Agenda
Village of Glen Ellyn
Architectural Appearance Commission Meeting
Wednesday, February 12, 2025
7:00 PM
Glen Ellyn Civic Center, Galligan Board Room

DRAFT MINUTES
Glen Ellyn Architectural Appearance Commission
Wednesday, December 5, 2024 at 7:00 P.M.
Glen Ellyn Civic Center
Galligan Board Room
535 Duane Street

1. 551 Crescent Blvd. – Exterior Appearance Review for the new Metra Station in the CR Zoning District

1 TYPICAL ARCH EXTERIOR ELEVATION
3/8" = 1'-0"

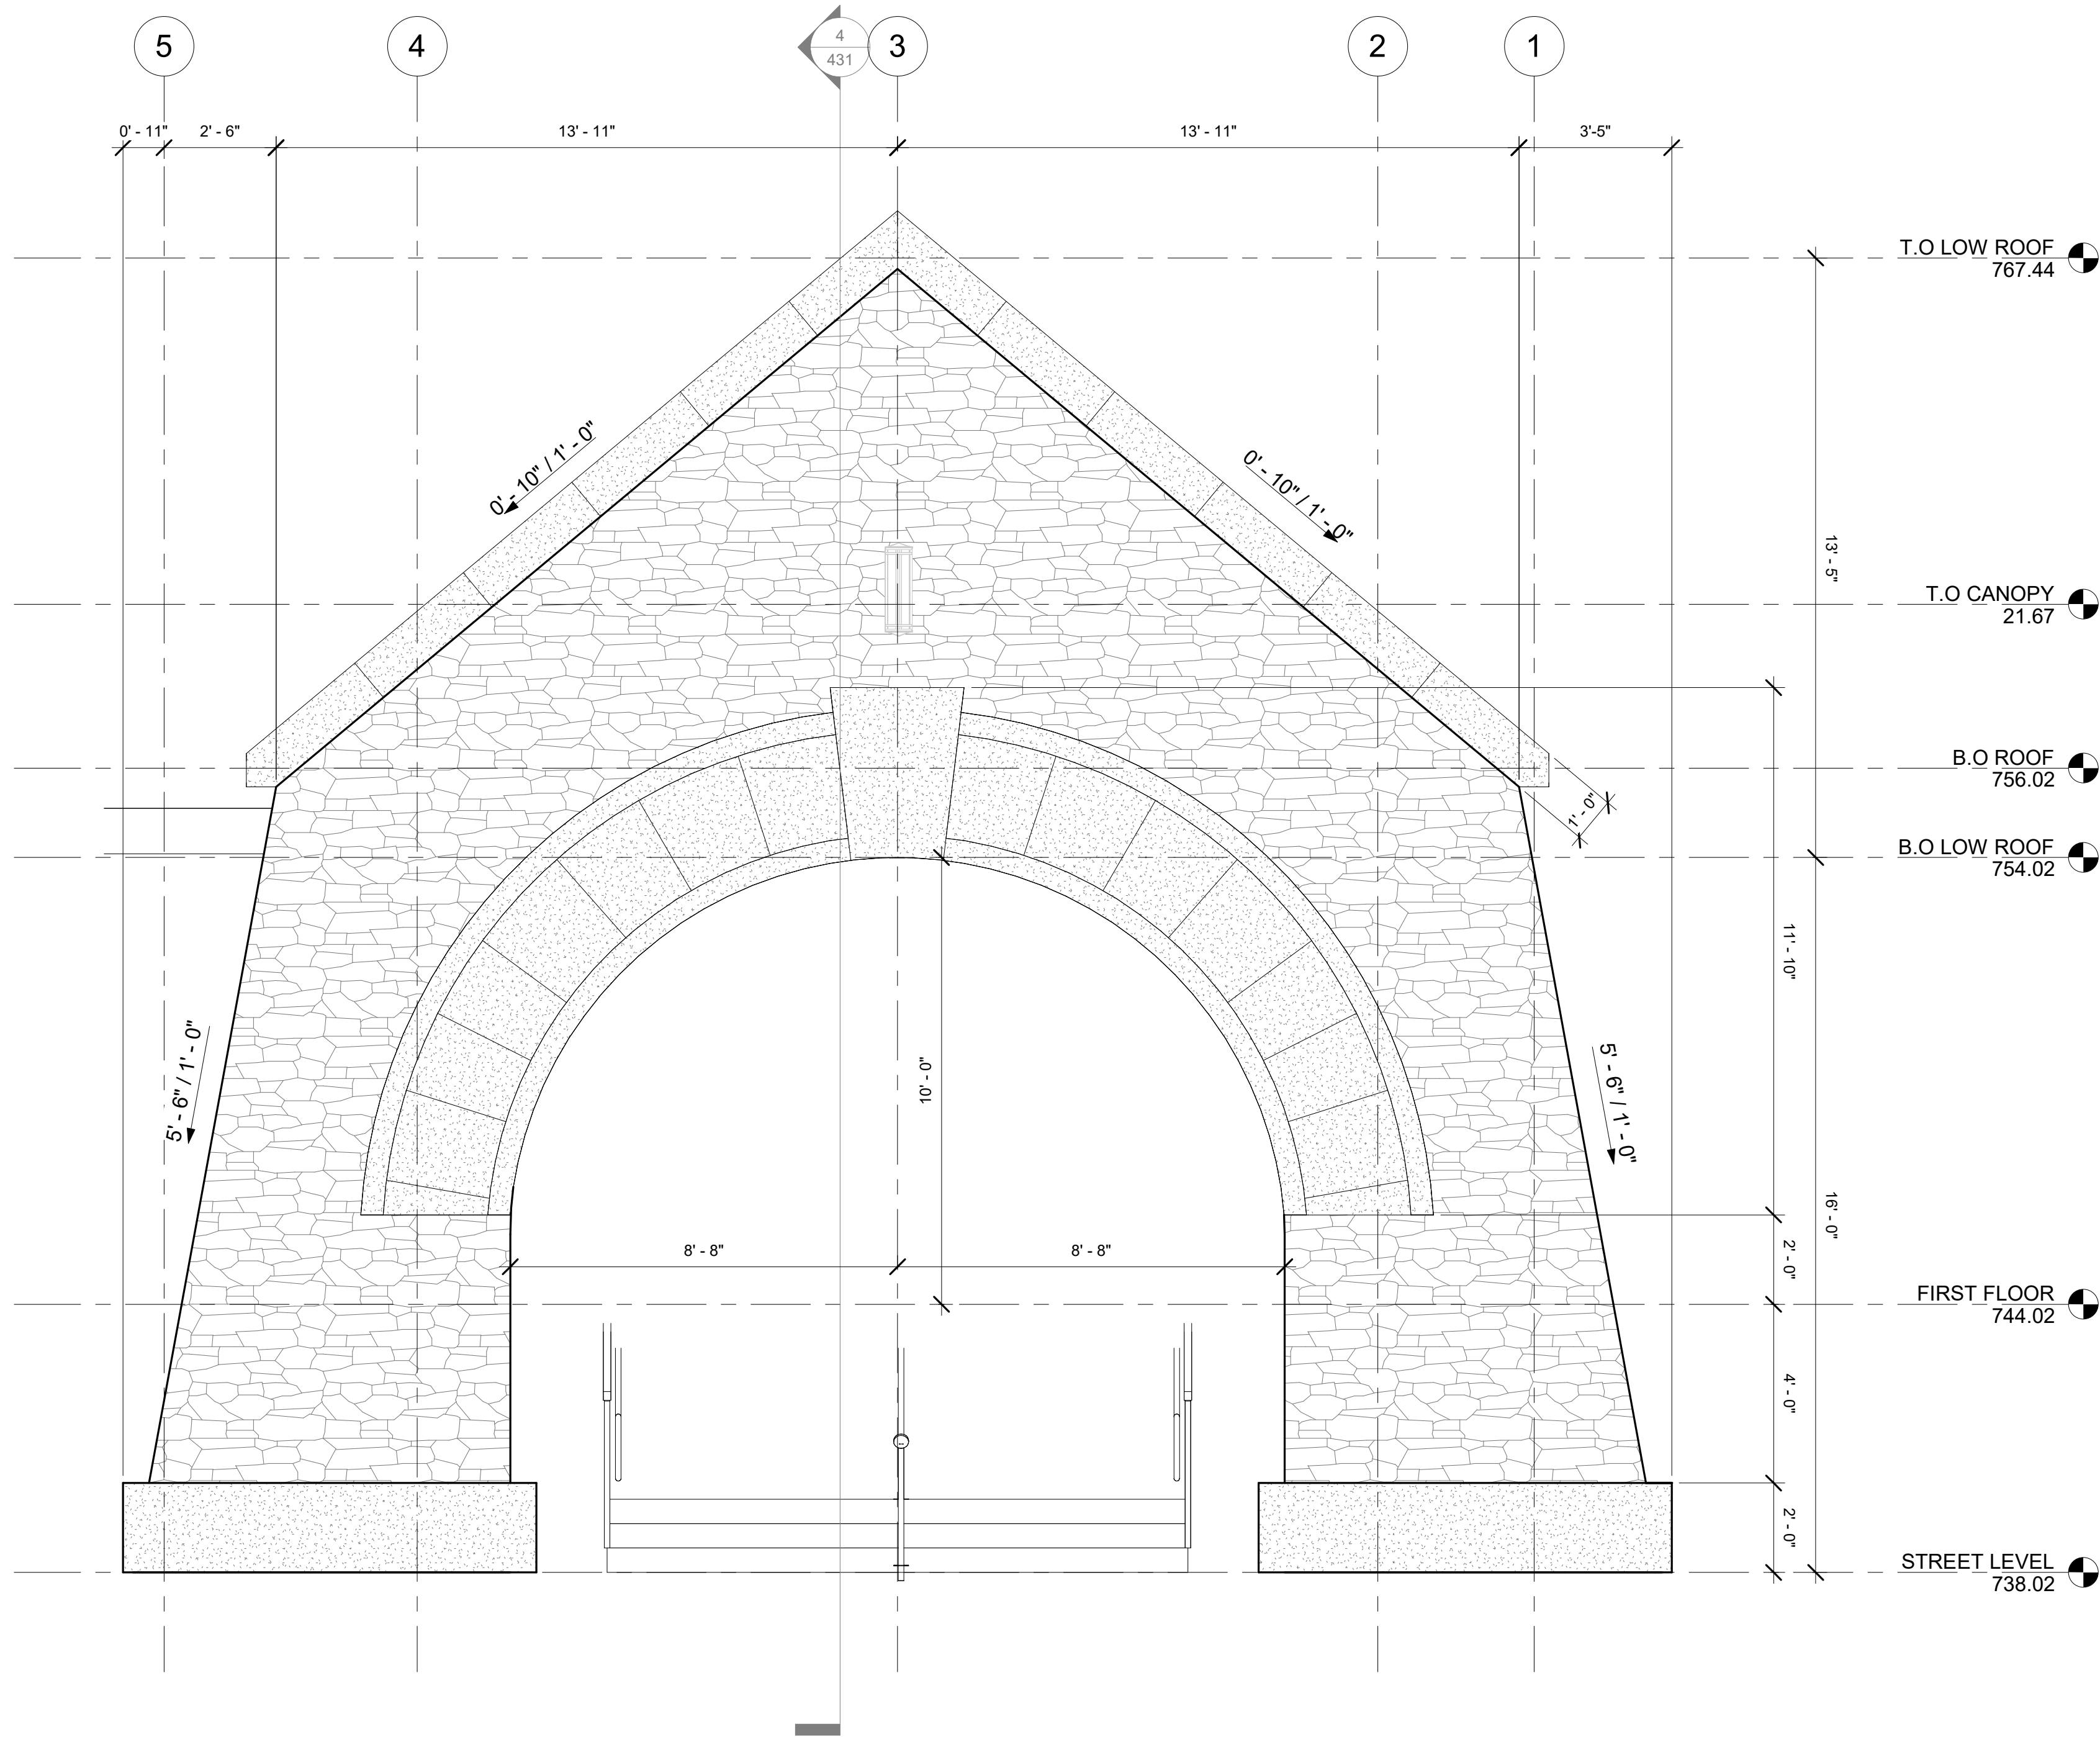
Commissioner Rahn stated he thinks the new canopy is unique but he battles with the arches at the main building. He asked if it was possible to change.

Commissioner Albrecht asked Ms. Sutherland if anything was coming to mind with the front elevation arches. Ms. Sutherland answered on simple idea is to change the arches to a simpler material. Mr. Daubert stated they will entertain these ideas and run past the Village Board. He stated staff has been given instructions to look at branding opportunities, but uniform stone would change the look of the arches.

1. Stone Arches – better align their design with the 1926 Station by removing the smooth surfaces and signage/branding
2. Barrel Ceiling of West Loggia – Remove soffits at arches
3. Lower Building Façade - Use more stone in lieu of brick from the ground to windowsills
4. Roof over southern Ramps/Stairs – Consider adding gables or other elements to break of the roofline which is long/monotonous

LANDSCAPE - OVERALL SITE PLAN

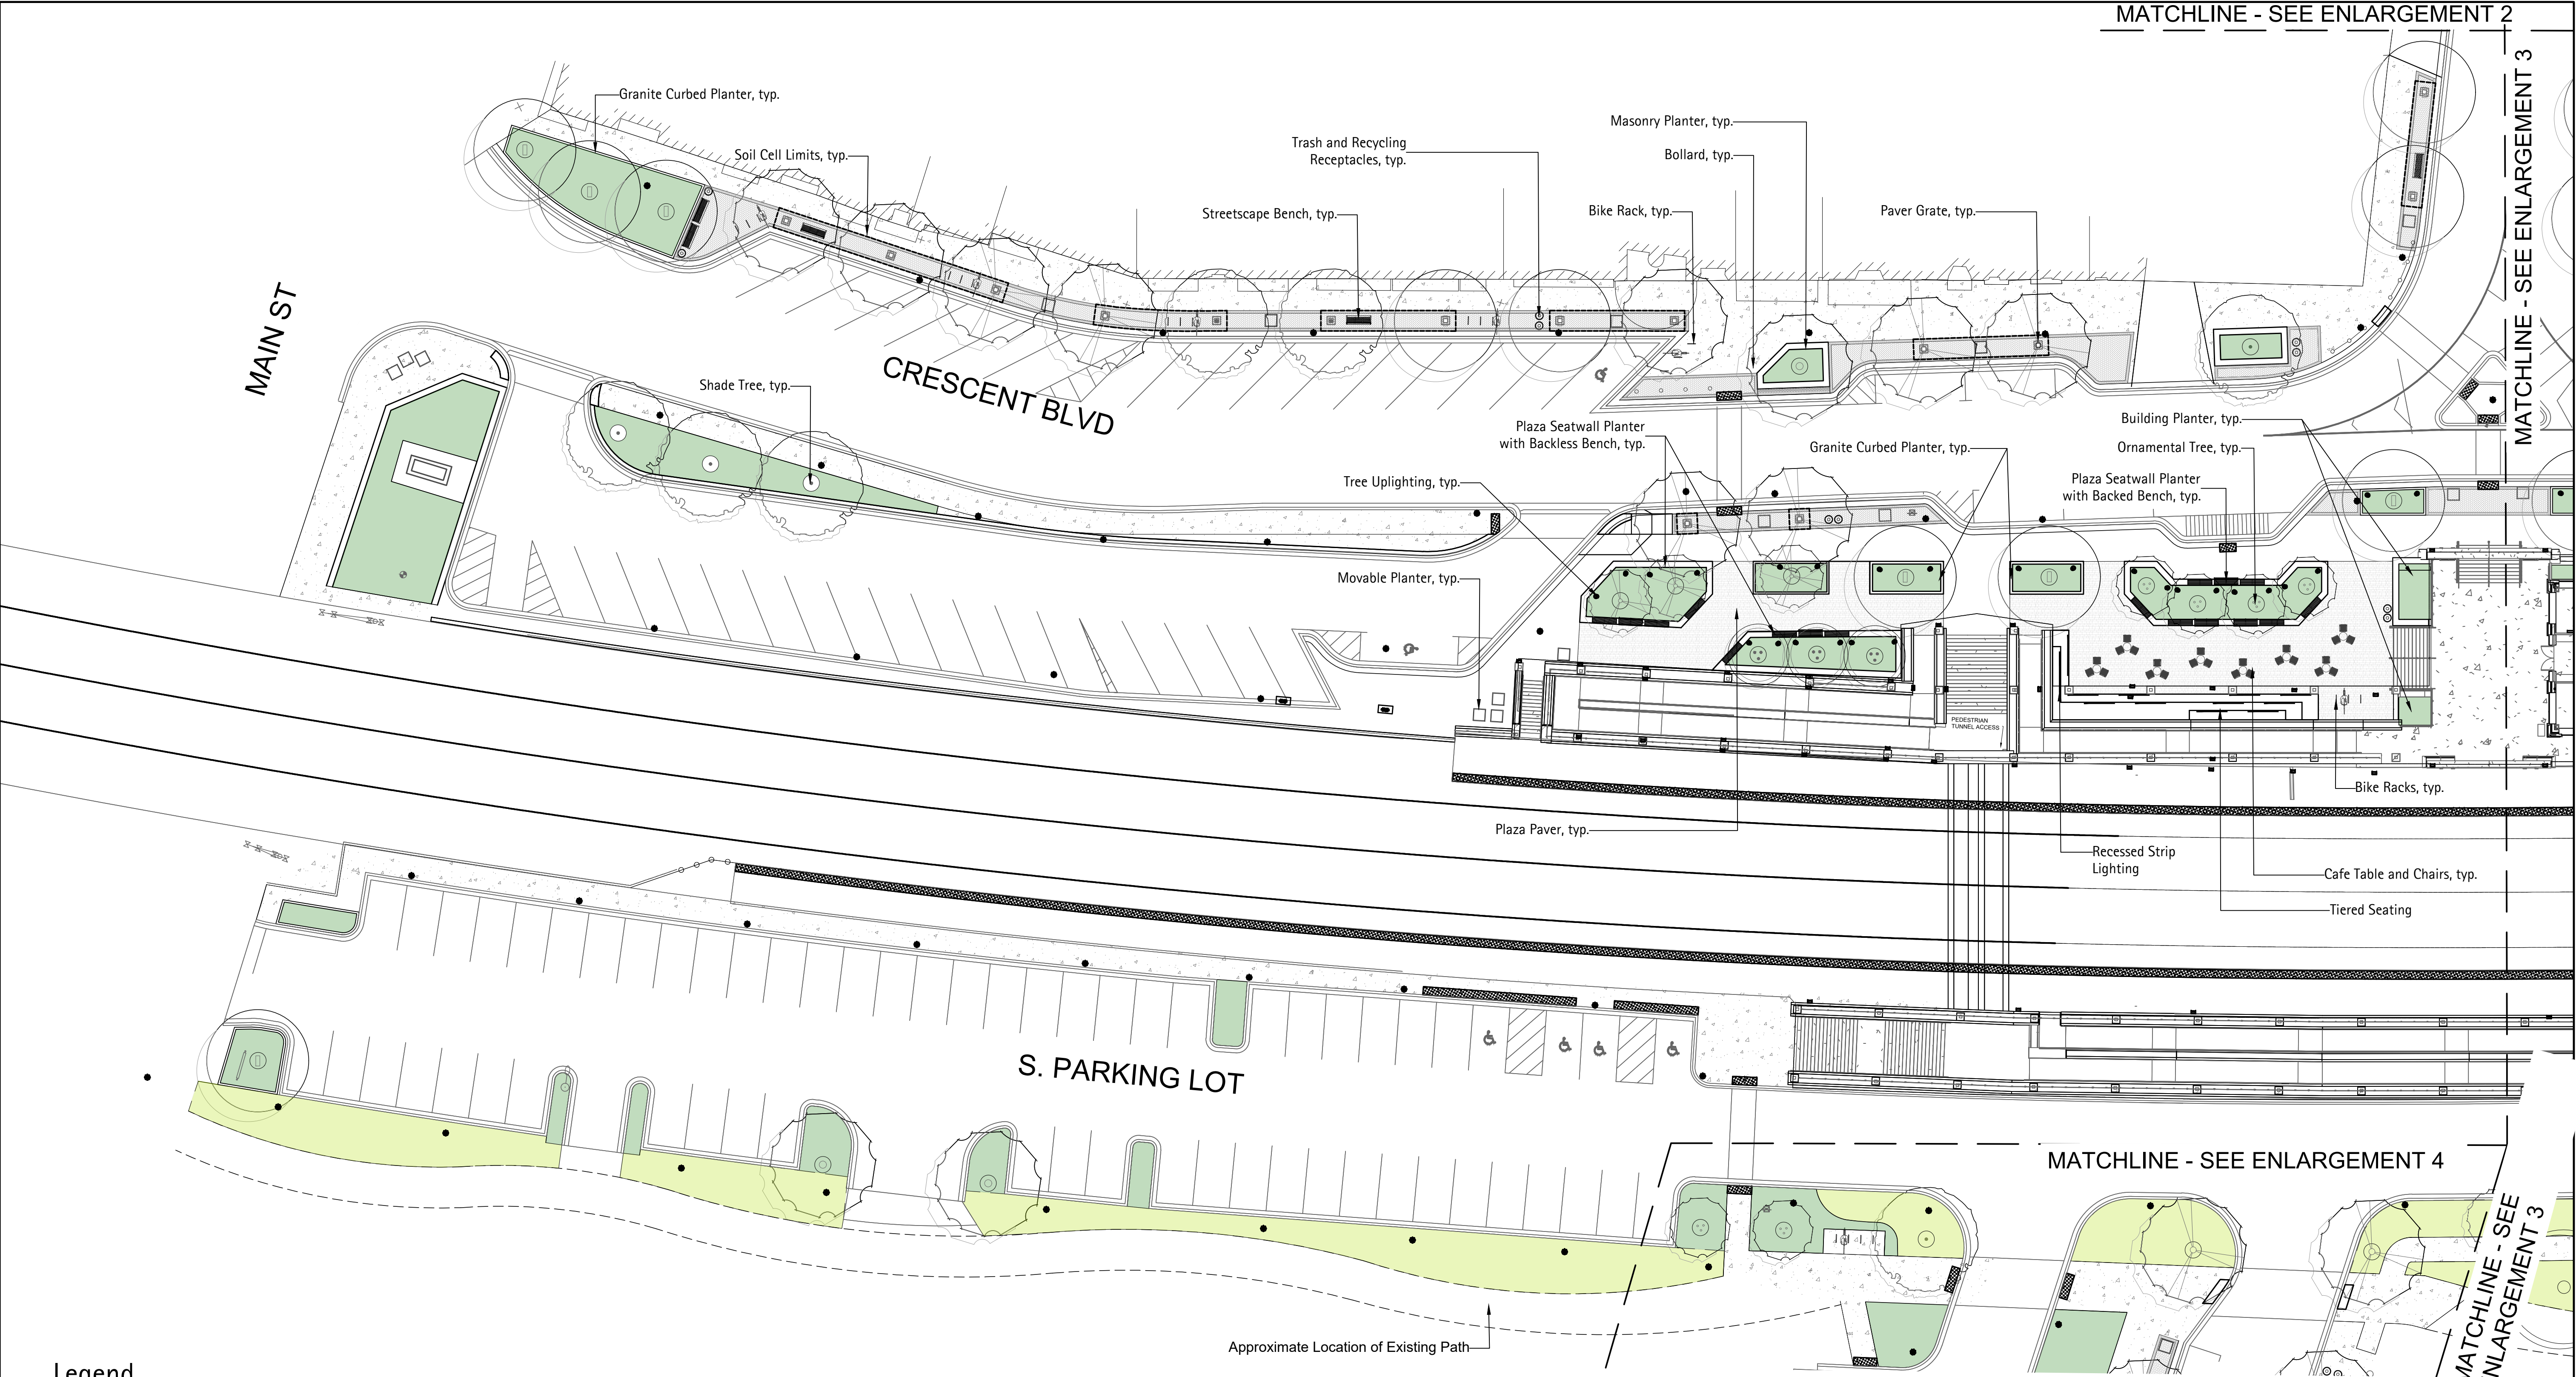
Commissioner Albrecht stated the landscaping on the southside looks like it was beefed up by the Prairie Path. Ms. Sutherland answered that it's all restoration in that area. Commissioner Albrecht asked if Ms. Sutherland could show the canopy view slide going into the tunnel. She said that looks nice. Commissioner Goranov stated it would look better with the columns. Commissioner Albrecht stated Ms. Sutherland did a great job in simplifying the materials.
